EL PASO COUNTY FILE NO.: PUD SP-22-006

# VILLAGES AT STERLING RANCH

## DEVELOPMENT PLAN & PRELIMINARY PLAN

# V3\_PUD Development Plan - v3 new design comments.pdf Markup Summary

**VILLAGES AT STERLING RANCH TRACT SUMMARY TABLE:**

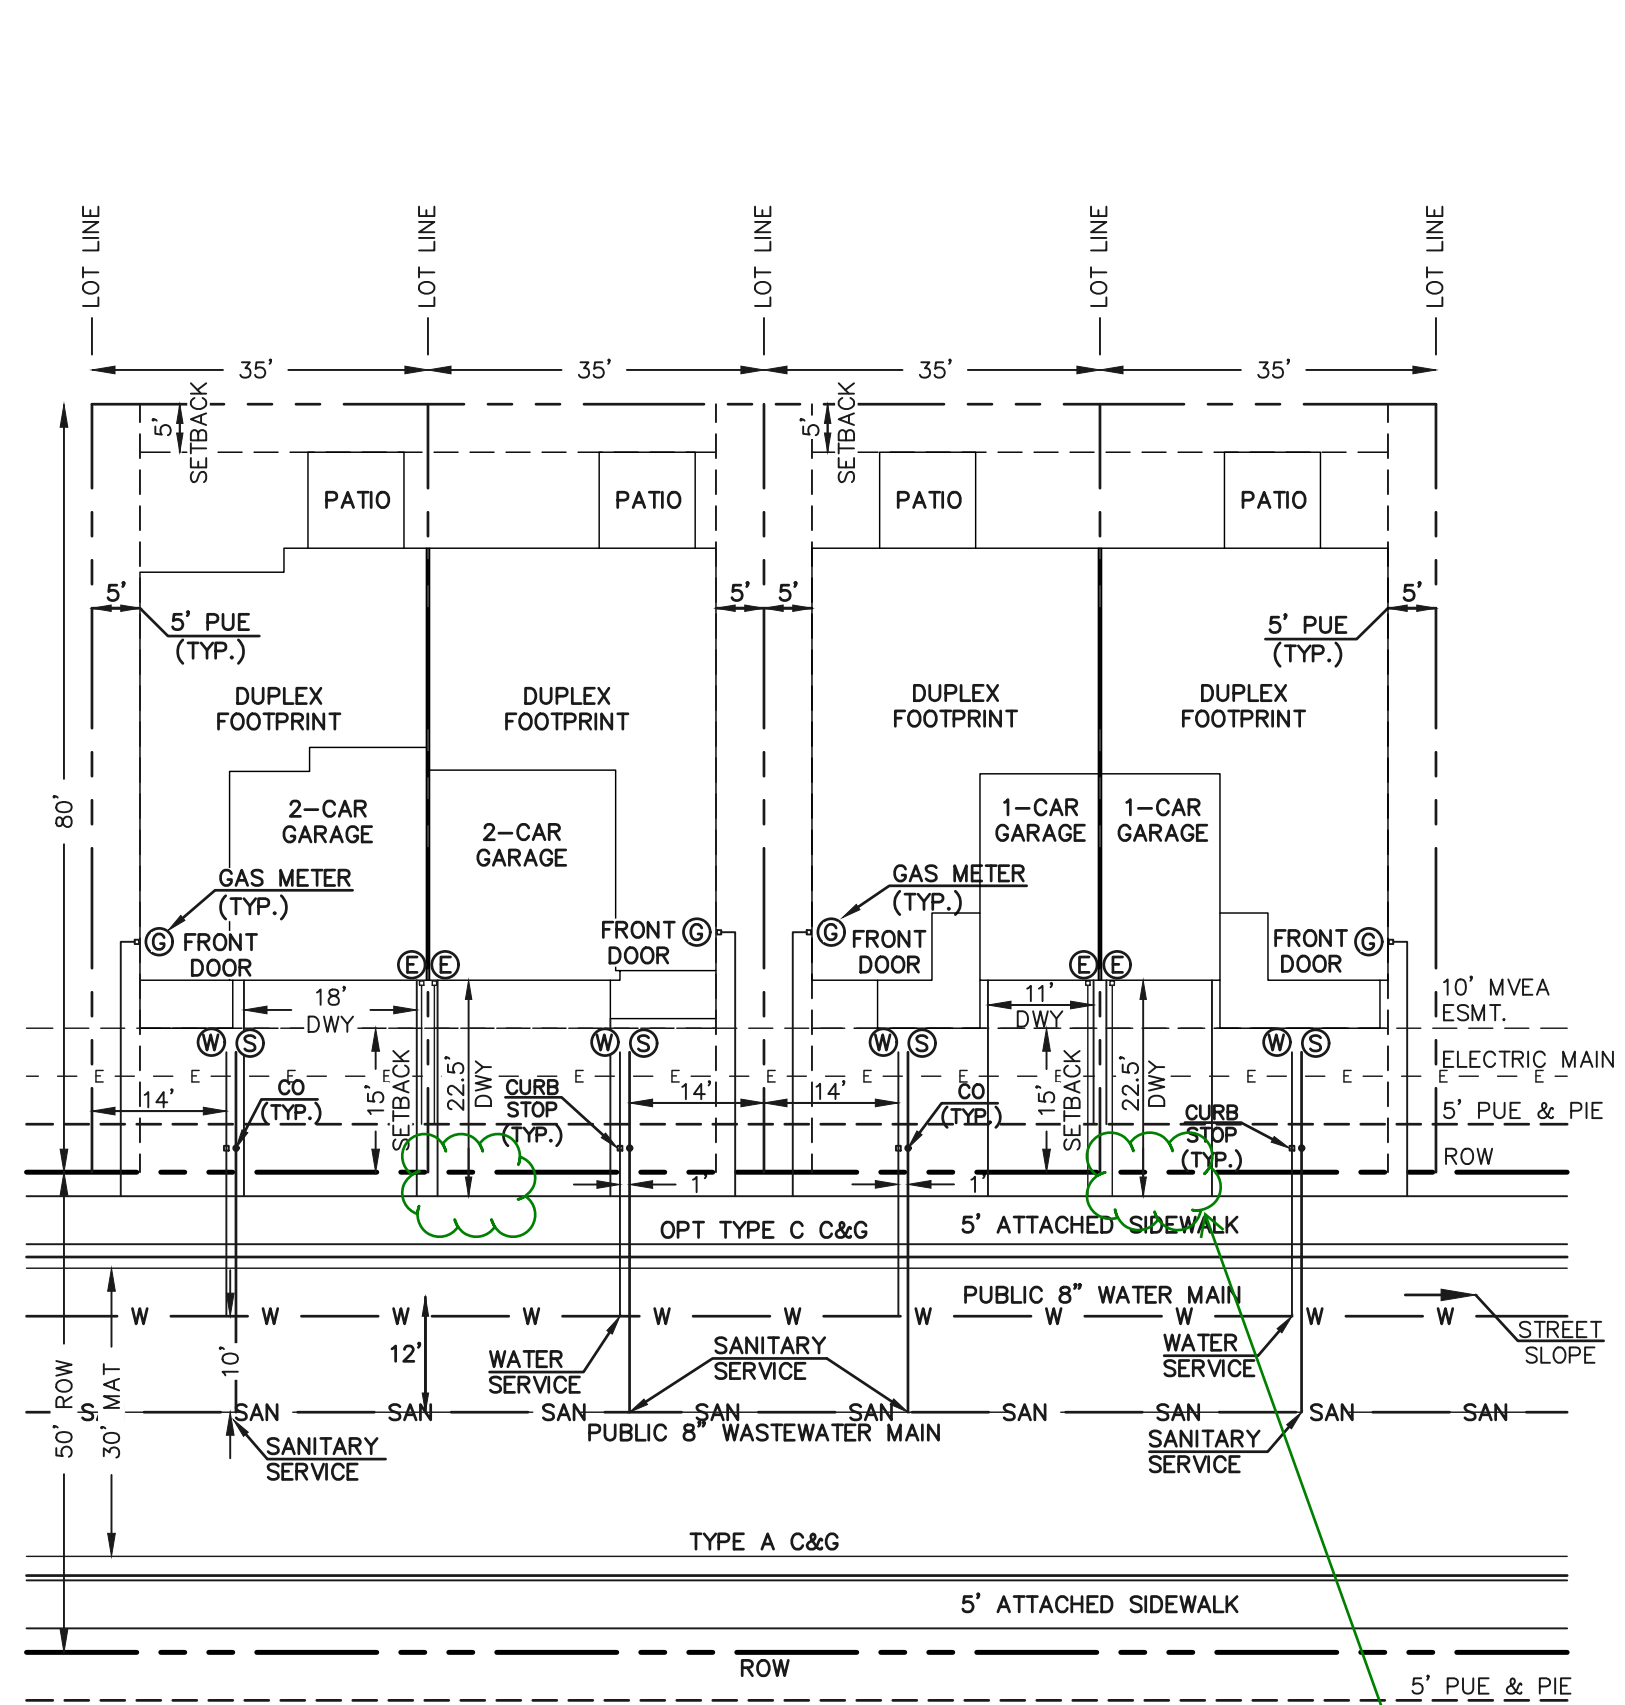
where is designated park site? looks like table has identified other uses in Park tract, which tract is Park

**TYPICAL LOT CONFIGURATION DETAIL – DUPLEX**  
**PUBLIC STREET (URBAN LOCAL, 50' ROW)**  
 CEDAR RAPIDS LOOP  
 SCALE: 1"=20' (H)  
 (ATTACHED SINGLE FAMILY)  
**LOTS 1-54**

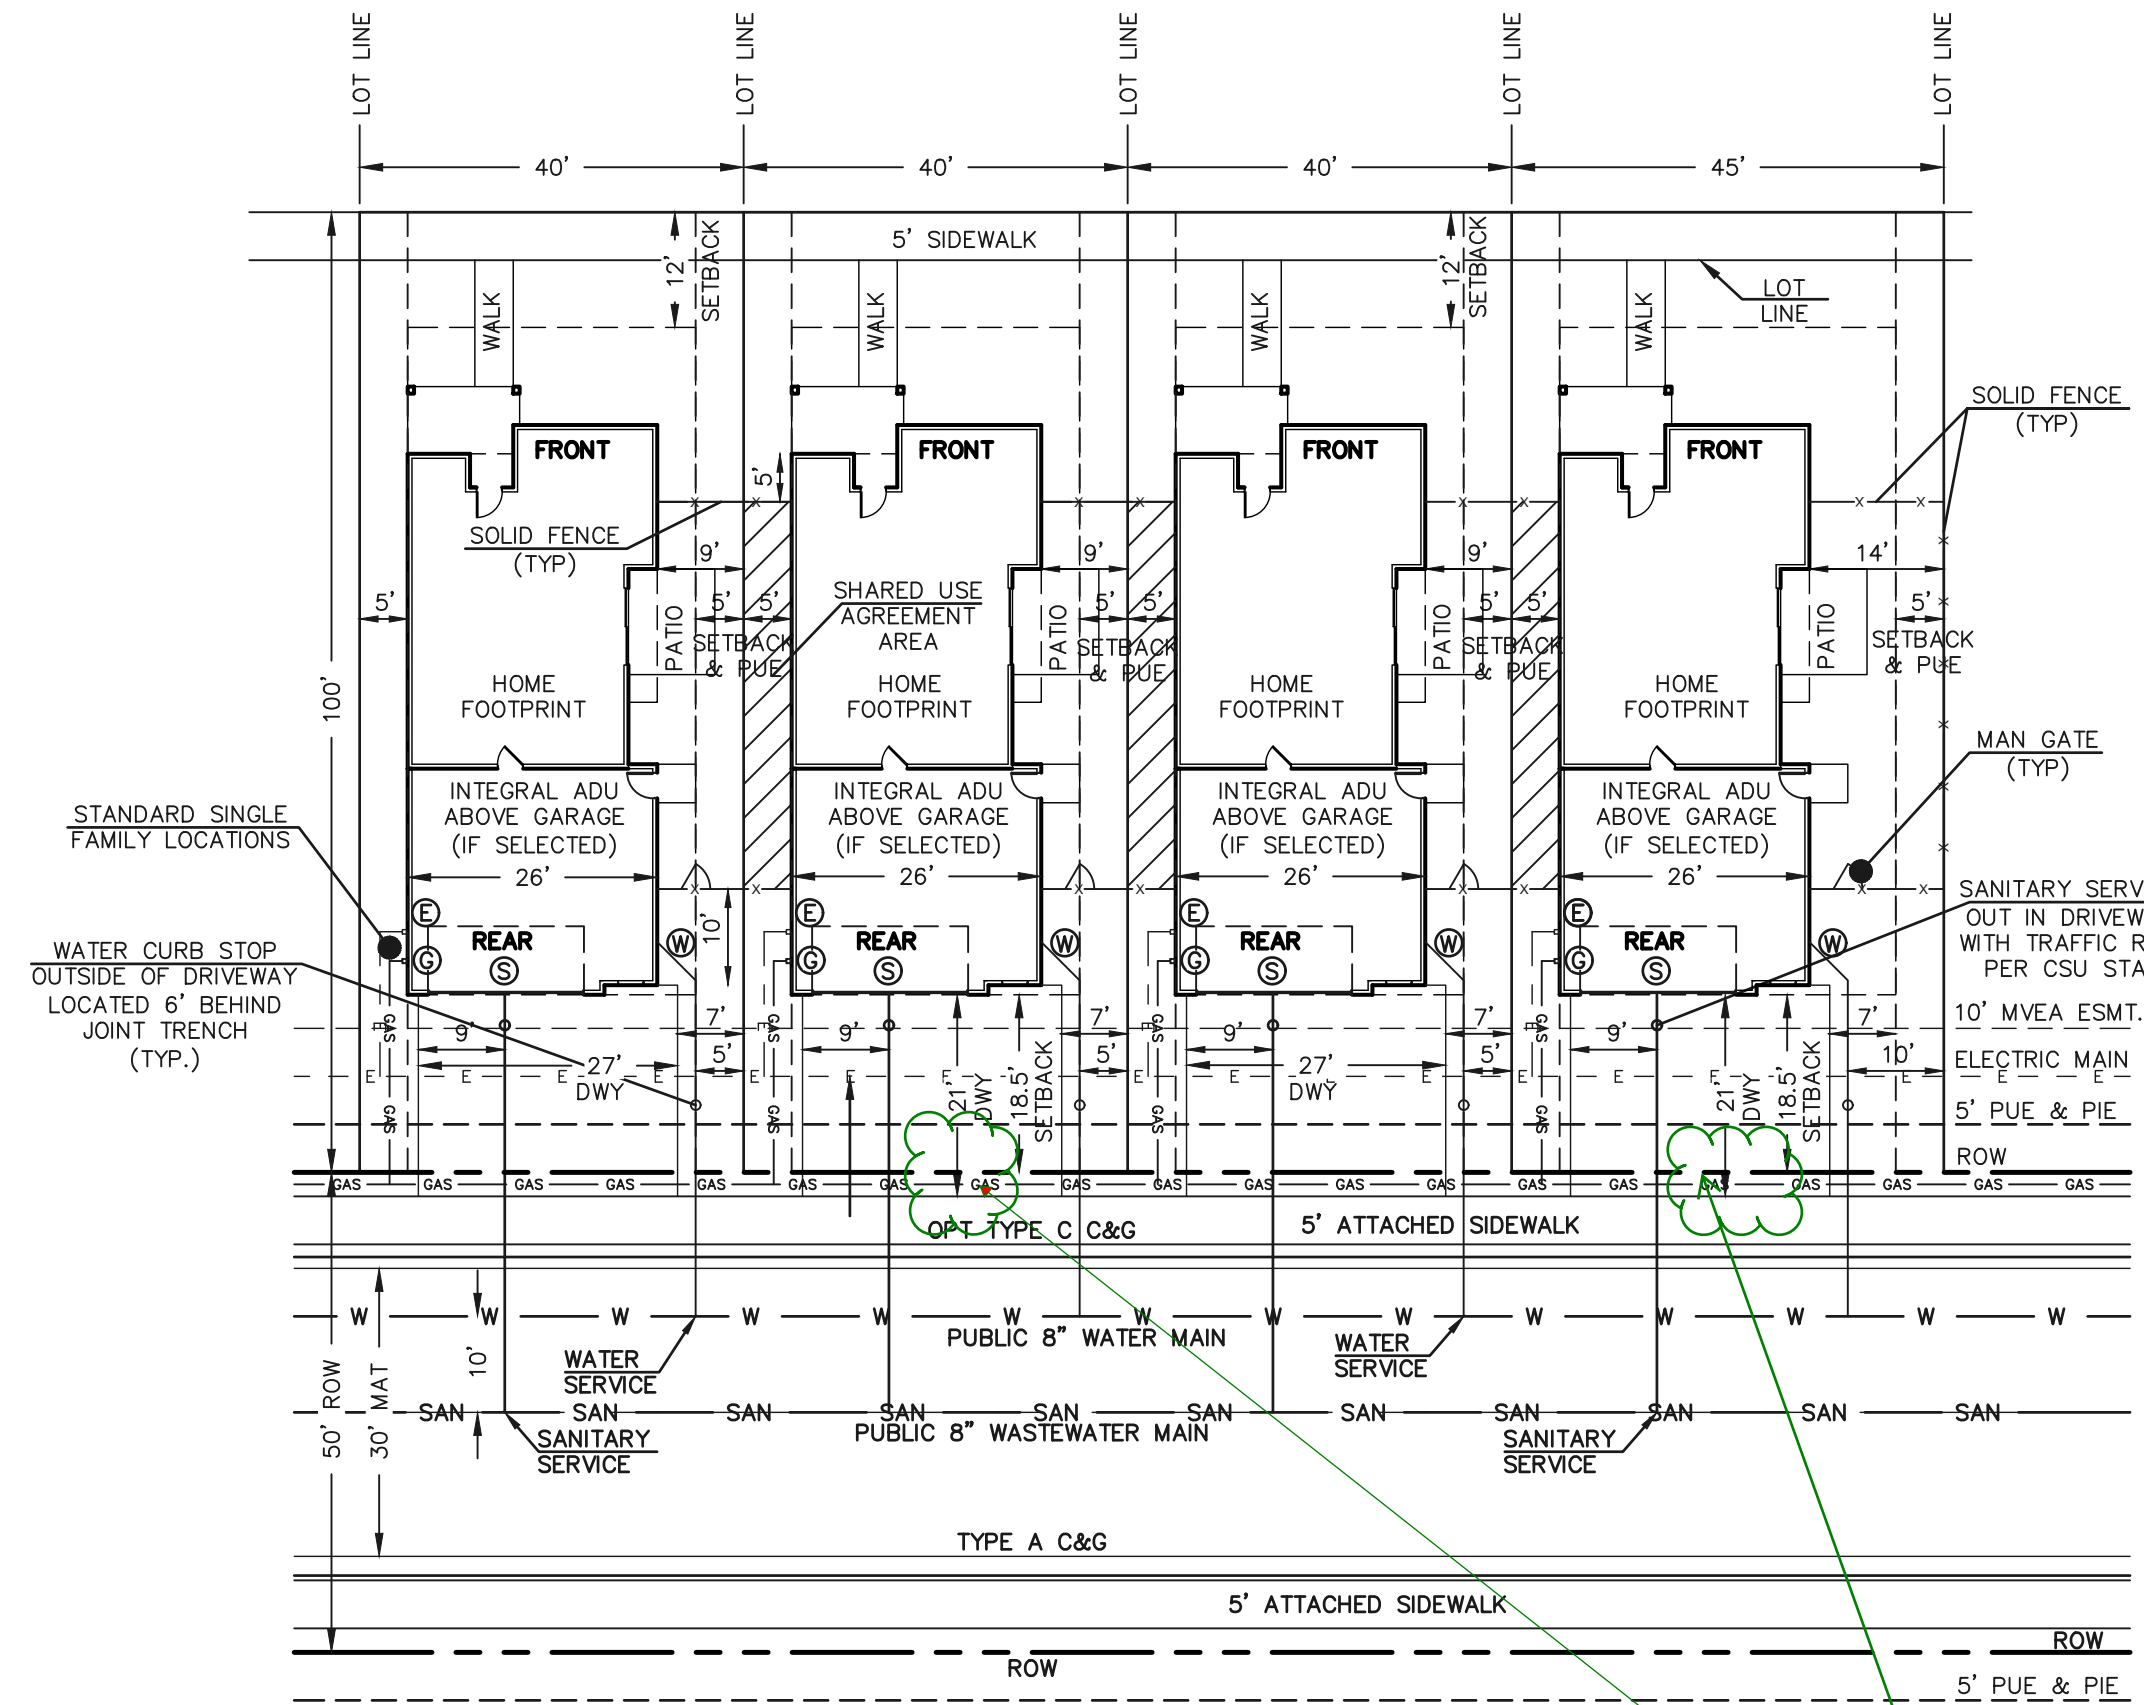
do the parking spots hang into public ROW? Do we need a license agreement?

Please verify setback for corner lots (15' is the setback from ROW)

**TYPICAL LOT CONFIGURATION DETAIL – ADU**  
**PUBLIC STREET**  
 SHOREWOOD DRIVE  
 SCALE: 1"=20' (H)  
 (DETACHED SINGLE FAMILY)  
**LOTS 55-66**

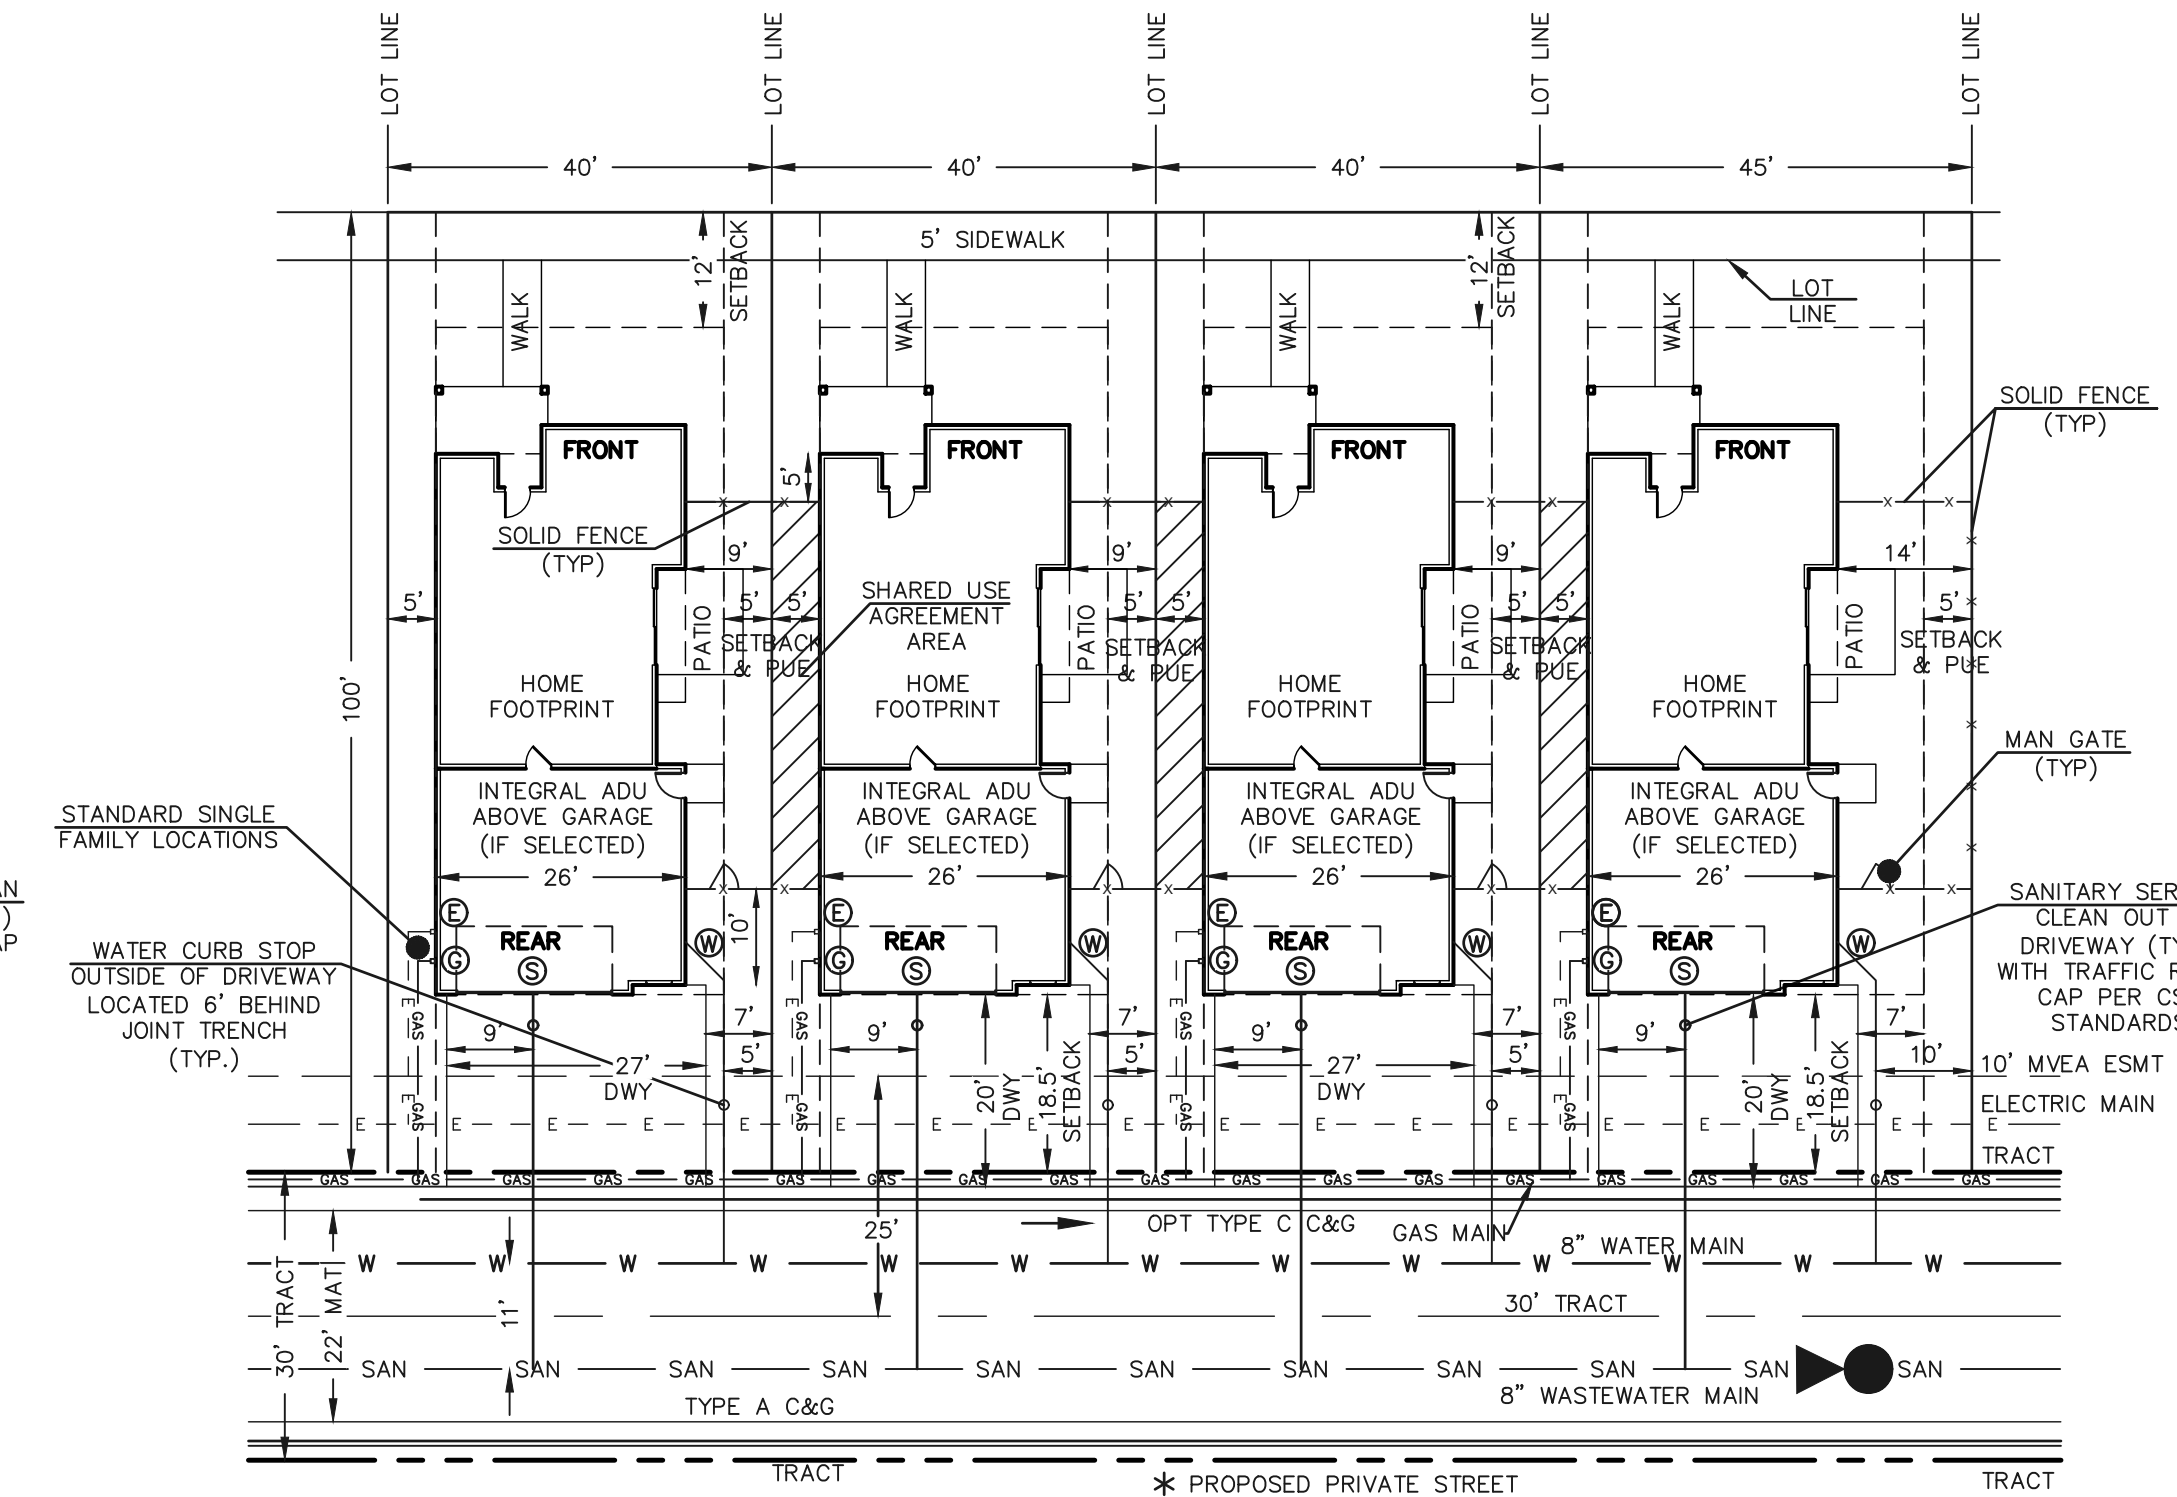
do the parking spots hang into public ROW? Do we need a license agreement?
